09/766,846

Hiroki Shinkawata

# Office Action Summary

## DETAILED ACTION

*FIG. 4B*

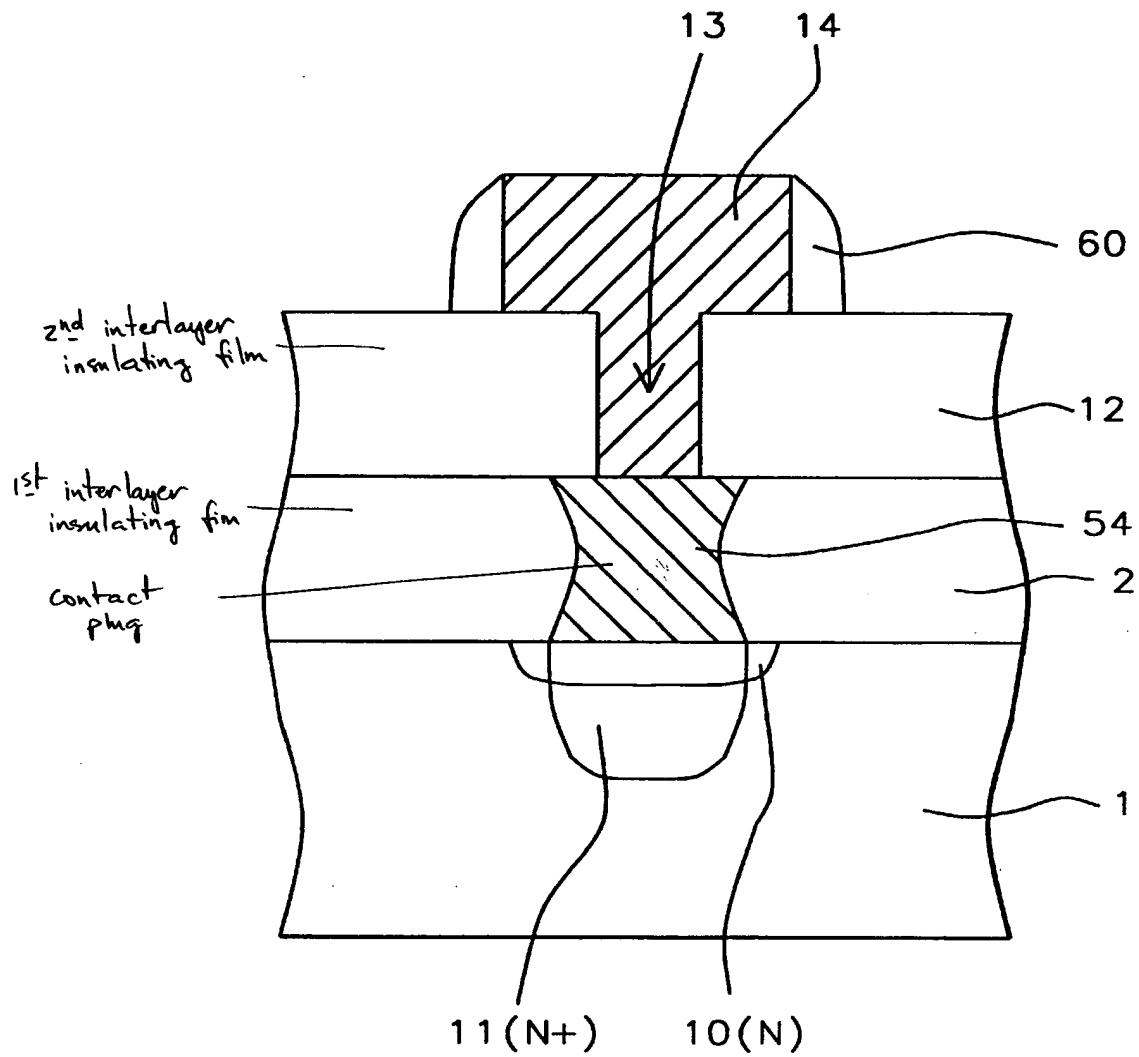
Sung discloses, as shown in Figures 4A-4B and 6B, a semiconductor device comprising,

conductive transfer gates (44);

contact plugs (50) adjacent to the conductive transfer gates, each contact plug and each conductive transfer gate having a respective upper surface, wherein the upper surfaces of the contact plugs and the upper surfaces of the conductive transfer gates are substantially coplanar;

each conductive transfer gate having a gate insulating film (3),

a gate electrode layer (4), and side walls (7) for covering sides of the gate insulating film and the gate electrode;

a first interlayer insulating film having a surface which defines the same surface as the upper surfaces as the upper surfaces of the conductive transfer gates and the contact plugs;

a second interlayer insulating film (12) formed on the first interlayer insulating film;

diameter-reduced contact plugs (13) which are smaller than the contact plugs and extend through the second interlayer insulating film to conduct to the contact plugs, respectively. Note attached red-line Figure 4B of Sung.
